WELL API NO. 30-015-54335
5. Indicate Type of Lease STATE [] FEE [x]
6. State Oil & Gas Lease No.
7. Lease Name or Unit Agreement Name FOUR LEAF CLOVER
8. Well Number 3H
9. OGRID Number 03080
10. Pool name or Wildcat WILDCAT G-01 S192617K; GLOR-YESO
11. Elevation (Show whether DR, RKB, RT, GR, etc.) 3385 GL

APD CHANGE OF PLANS FOR FOUR LEAF CLOVER 3H

ATTACHED ARE AMENDED C-102, AMENDED NGMP, AMENDED KOP AND AMENDED DIRECTIONAL PLANS

WELL LOCATION AND ACREAGE DEDICATION PLAT

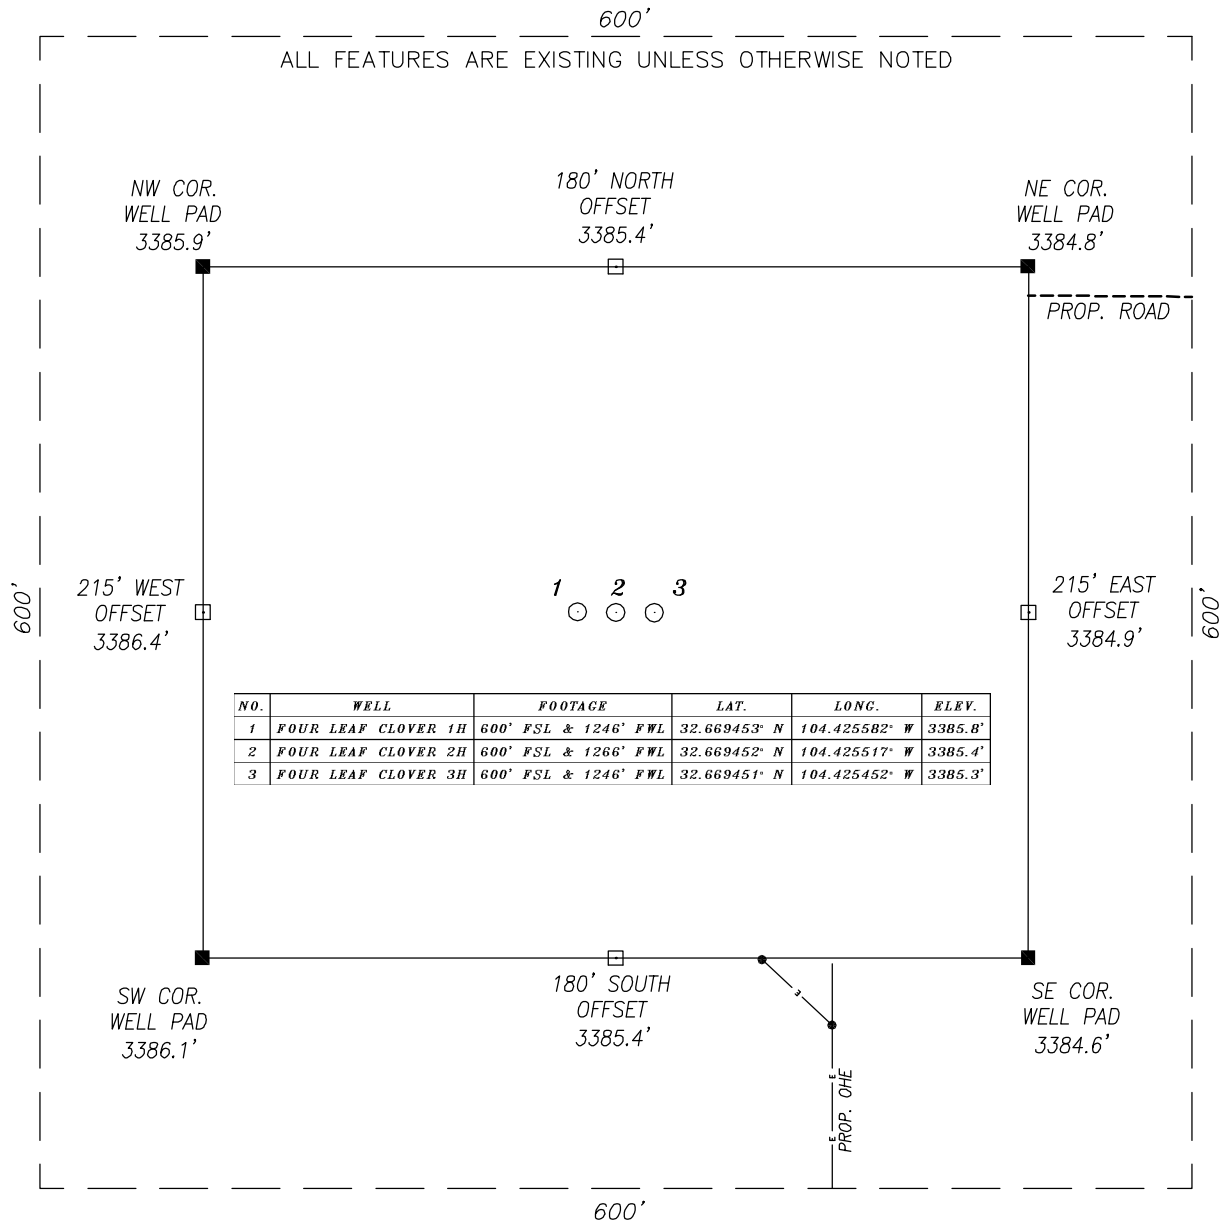
LOCATION FROM SEC 17 19S 26E UNIT E 1395 FNL 800 FWL TO SEC 7 19S 26E UNIT M 600 FSL 1286 FWL

UL or lot No.	Section	Township	Range	Lot Idn	Feet from the	North/South line	Feet from the	East/West line	County
4	7	19-S	26-E		600	SOUTH	1286	WEST	EDDY

UL or lot No.	Section	Township	Range	Lot Idn	Feet from the	North/South line	Feet from the	East/West line	County
N	18	19-S	26-E		101	SOUTH	2182	WEST	EDDY
